## COAL MINING AND RECLAMATION PERMIT APPLICATION TO REVISE A PERMIT (ARP)

**ARP Type:**  
Pond Construction

**Permit Number:** D-1159  
**Application Number** R-1159-2

Bennoc, Inc.  
ARP R-1159-2  
Review Comments  
Jeff Emmons  
November 14, 2001

ADDENDUM TO APPLICATION TO REVISE  
PERMIT D-1159, ITEM 4.

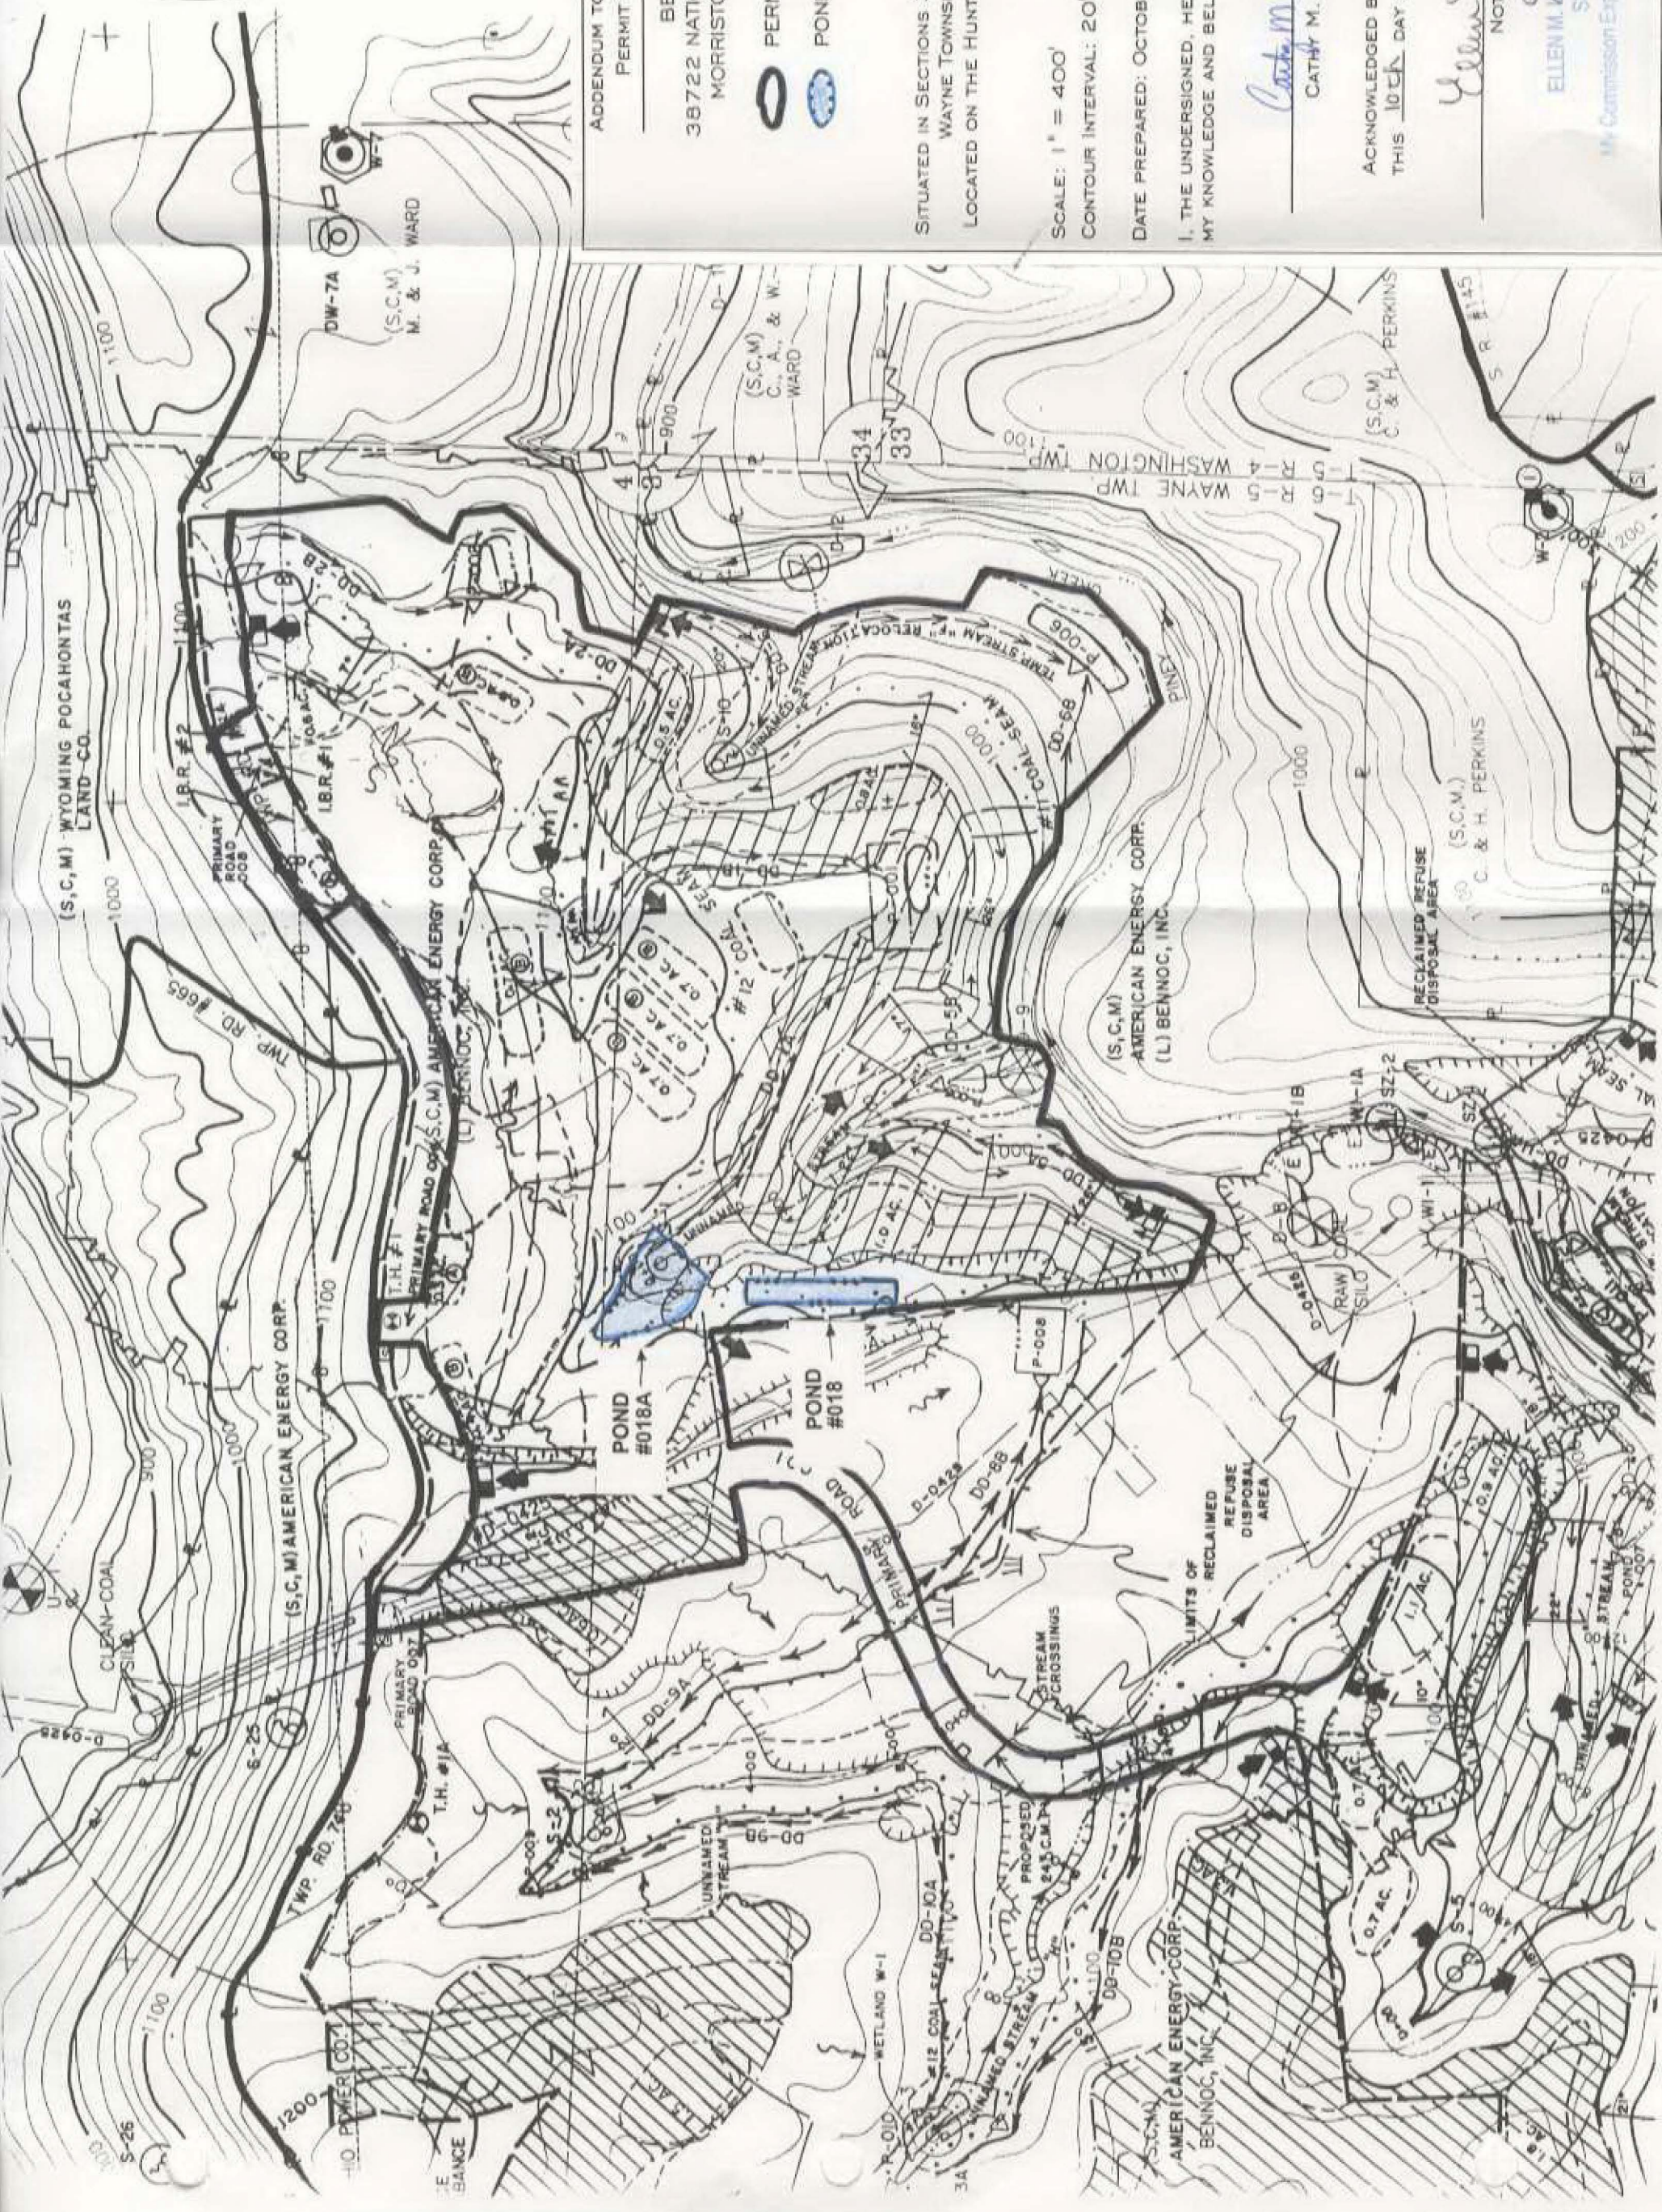
1. Revise item 5 of the ARP to briefly address how this proposed change will affect the approved drainage control plan (ie. pond 5 will be built smaller, pond 5 will not be built as #11 coal will not be mined in this watershed, etc.).
2. If diversion ditches will be constructed in association with the proposed ponds, show their proposed location on the map and submit designs as necessary.
3. Proposed temporary pond 18A will be constructed in the buffer zone of an intermittent stream. Submit a buffer zone variance request.

1. Revised Item 5. of the A.R.P. to briefly discuss how the proposed change will affect the approved drainage control plan.
2. No new diversions will be constructed.
3. Submitting a Stream Buffer Zone Variance Request for Unnamed Stream "E".

Also added Stream Buffer Zone to A.R.P. map legend.
